August 1, 2025

**ADDENDUM NO. 2
TOLEDO BEND PROJECT JOINT OPERATION
Hydro Station Outage Unit #2 RFB# 26-001**

THIS ADDENDUM IS ISSUED FOR THE PURPOSE OF AMENDING THE CONTRACT DOCUMENTS FOR THE SABINE RIVER AUTHORITY OF TEXAS AND SABINE RIVER AUTHORITY OF LOUISIANA AS FOLLOWS:

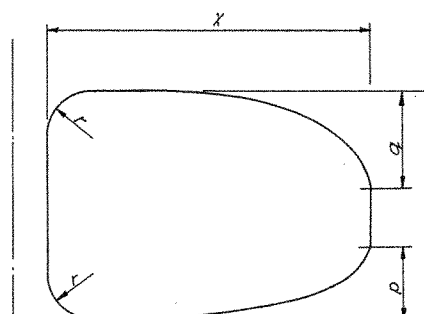
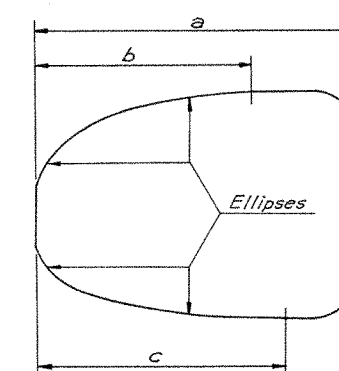
Plans: Plan sheets PS-5 & PS-6 are hereby included with the contract documents for contractor information regarding elevations, and dimensional information of the generator draft tubes.
